April 18, 2024, Standards Committee Meeting

RE: Minutes from the April 18, 2024, Standards Committee Meeting

Standard Drawing:
E 609-RCBA-04

REINFORCED CONCRETE BRIDGE APPROACH SECTION,
PAVEMENT LEDGE, AND BAR BENDING DETAILS

E 609-RCBA-04 REINFORCED CONCRETE BRIDGE APPROACH SECTION, PAVEMENT LEDGE, AND BAR BENDING DETAILS (with shown markups)

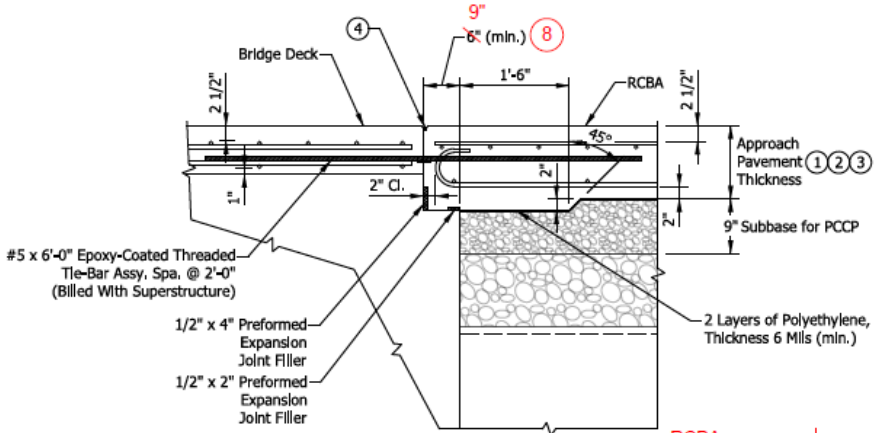
PROBLEM(S) ENCOUNTERED: The current standard pavement ledge width of 6” can create vulnerabilities to future settlement of the RCBA relative to the bridge deck. The concrete-to-concrete bearing width is only 3 ½” after subtracting the widths of the PEJF material, so even a relatively small amount of deterioration or poor concrete consolidation can result in insufficient bearing capacity, which can lead to settlement. It has also been observed that the interface between the end of the RCBA and adjoining HMA pavement, when no terminal joint is required, can develop a slight separation that can allow water infiltration.

This item was introduced and presented by Mr. White, who stated that the current standard pavement ledge width of 6 in. can create vulnerabilities to future settlement of the RCBA relative to the bridge deck. The concrete-to-concrete bearing width is only 3 ½ in. after subtracting the widths of the PEJF material, so even a relatively small amount of deterioration or poor concrete consolidation can result in insufficient bearing capacity, which can lead to settlement. It has also been observed that the interface between the end of the RCBA and adjoining HMA pavement, when no terminal joint is required, can develop a slight separation that can allow water infiltration.

Mr. Reilman asked how the joint between the RCBA and the adjoining HMA will be filled. Mr. White said it will be Hot Poured Joint Sealant as shown on the drawing. Mr. White said a RPD may be helpful until the revised standard drawing is effective.

PROPOSED SOLUTION: Increase the standard pavement ledge width from 6” to 9” and add a detail to seal the interface between the end of the RCBA and adjoining HMA pavement when no terminal joint is required.

Mr. White proposed to increase the standard pavement ledge width from 6 in. to 9 in. and add a detail to seal the interface between the end of the RCBA and adjoining HMA pavement when no terminal joint is required.
